CITY OF ALBUQUERQUE

**RE: Sony Imageworks @ Mesa del Sol Grading Plan
Engineer's Stamp dated 2-4-08 (R16/DA3006)**

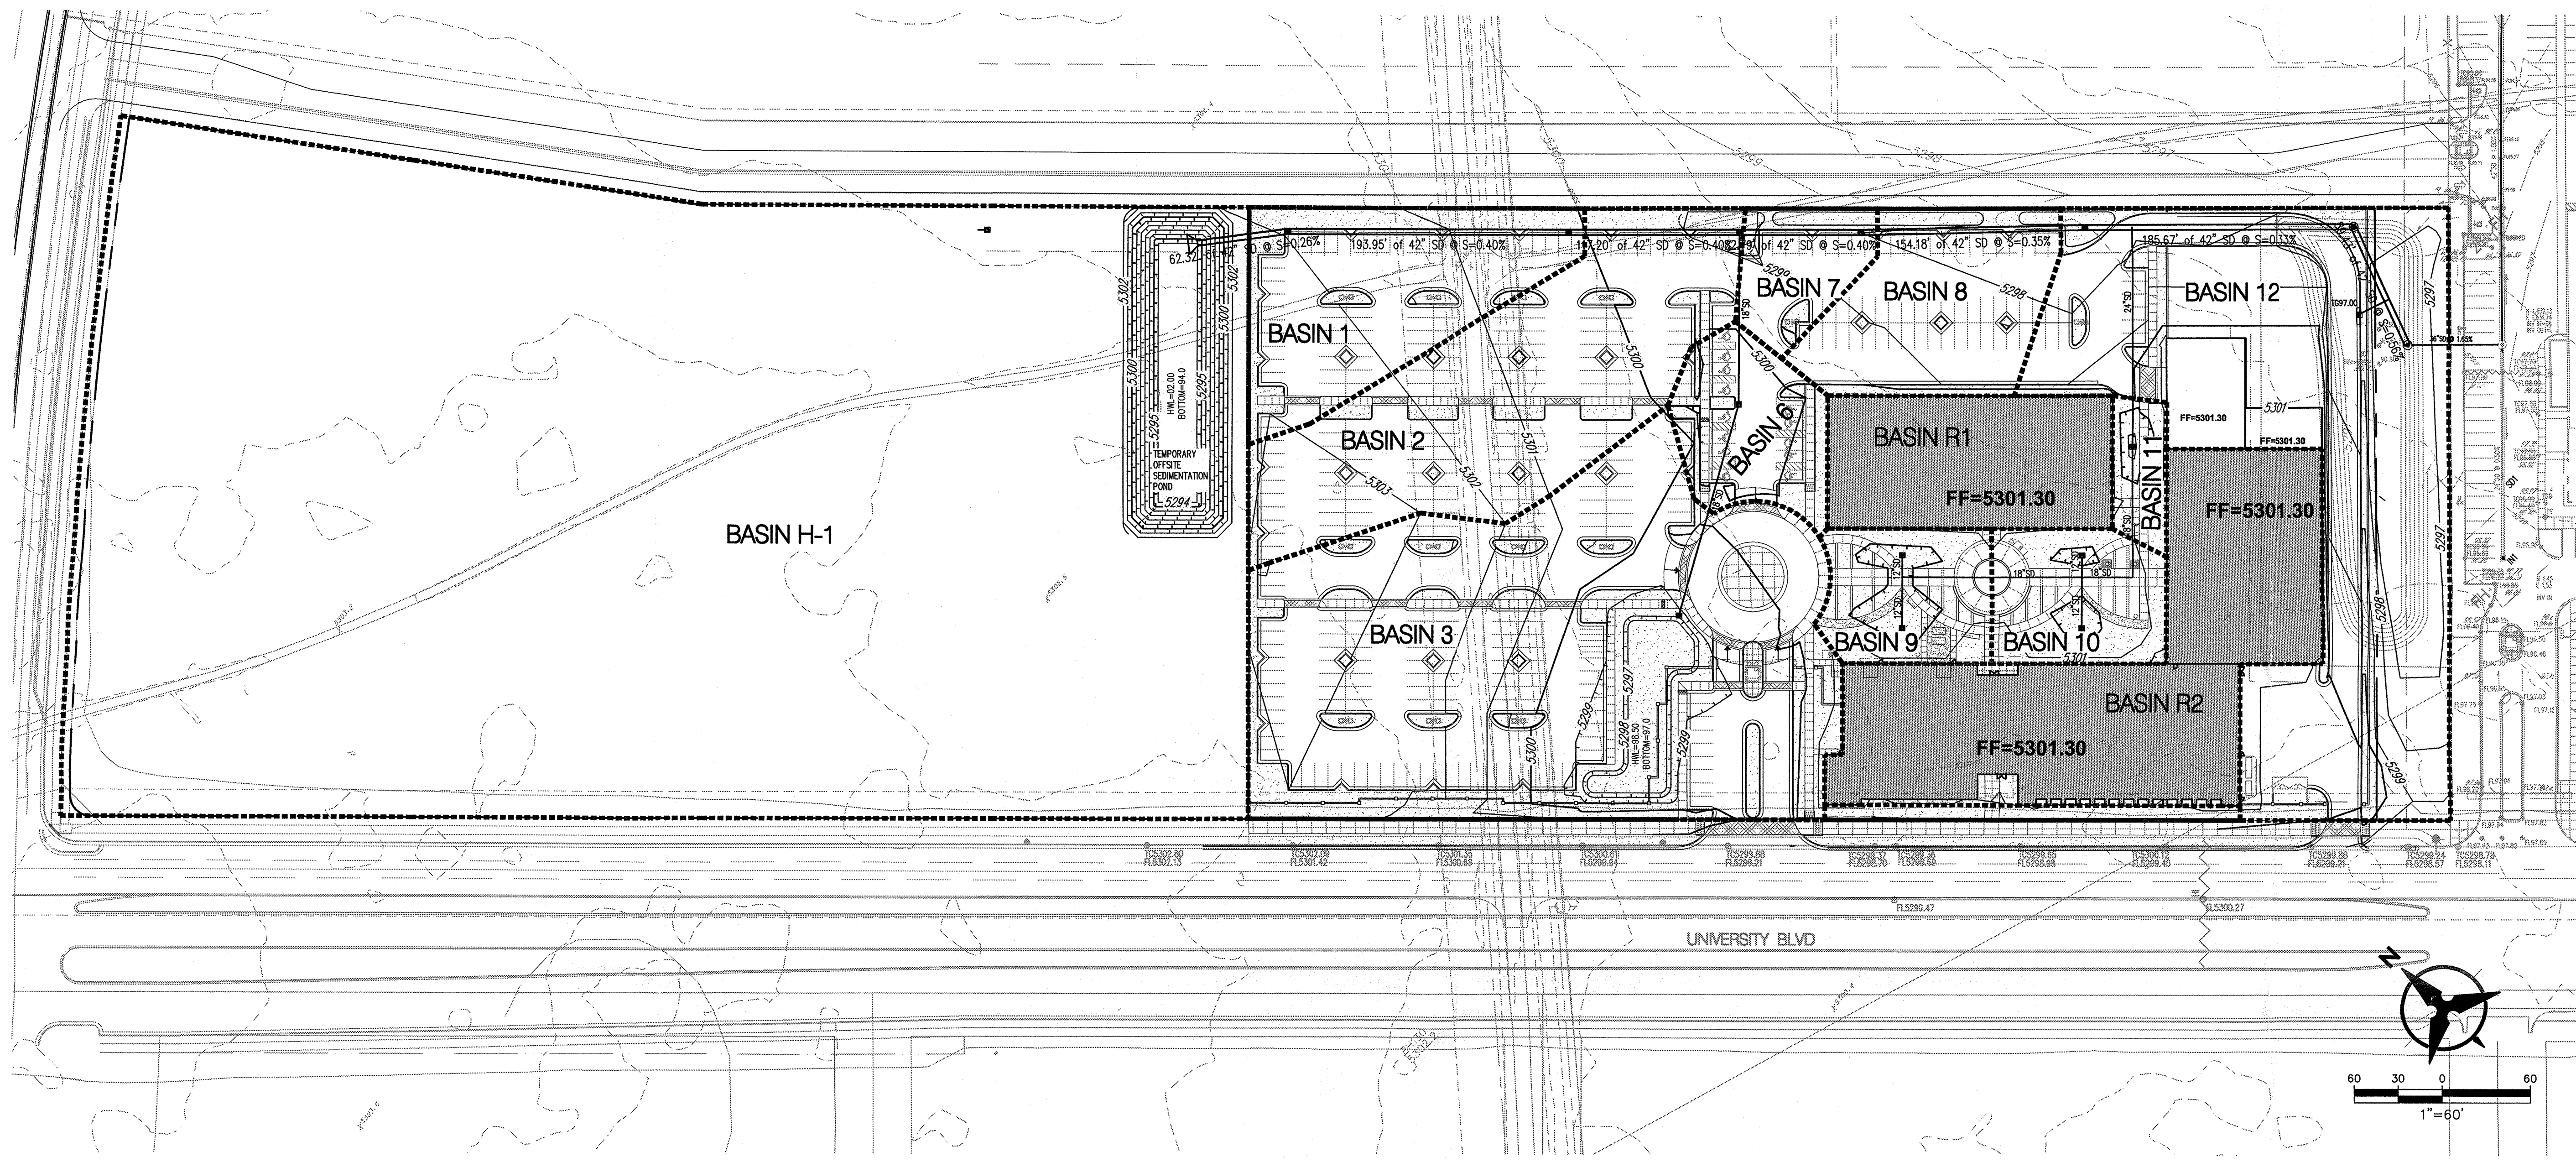
The land treatments in this submittal do not agree with the land treatments in the Drainage Area 3 Drainage Management Plan, stamp date 7-24-07. This may have an impact on pond volumes.
